Informations techniques/Technical Matters

DATE October 27th, 1971.SUBJECT: 1972 GRAND PRIX- SLIDER SUSPENSION.RE: RETAINING BOLTS OF THE FRONT AND REAR TENSIONER ARMS.

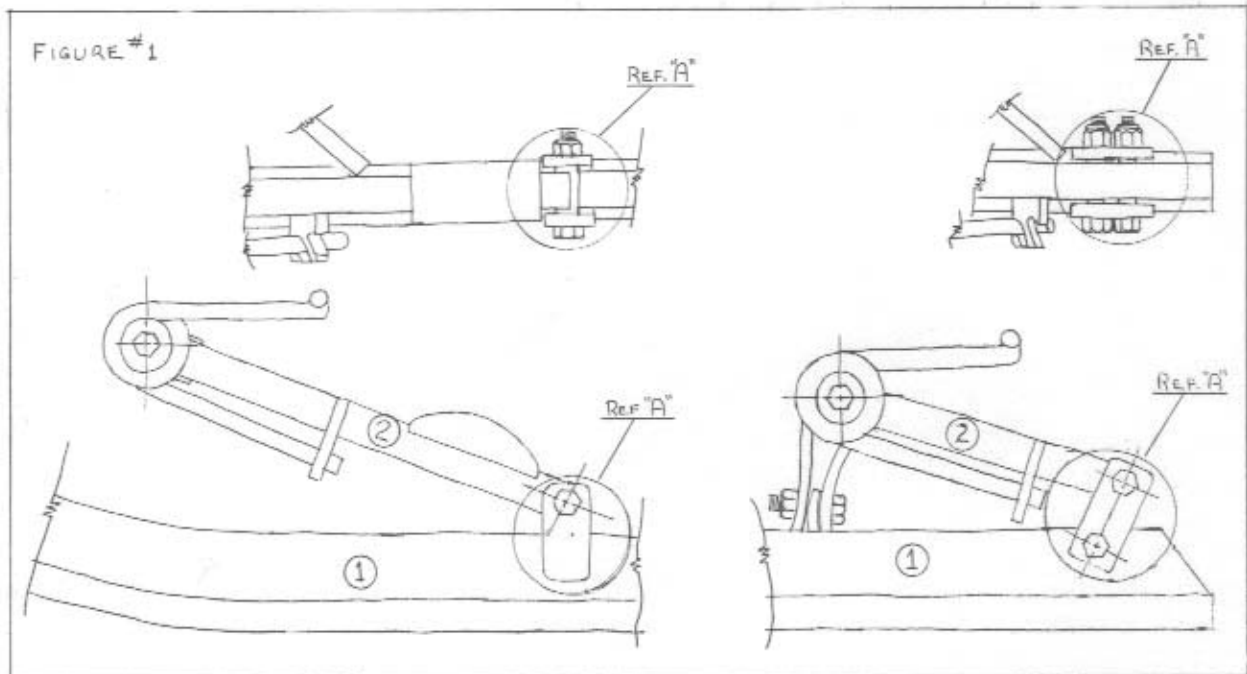
Take note that the tensioner arms (ref. 2, fig. 1) of the slides (ref. 1) should be allowed to move freely.

Therefore, these bolts (ref. A, fig. 1) should never be fully tightened. When assembling or repairing a slider suspension, make sure that these bolts are not restricting the movement of the tensioner arms.
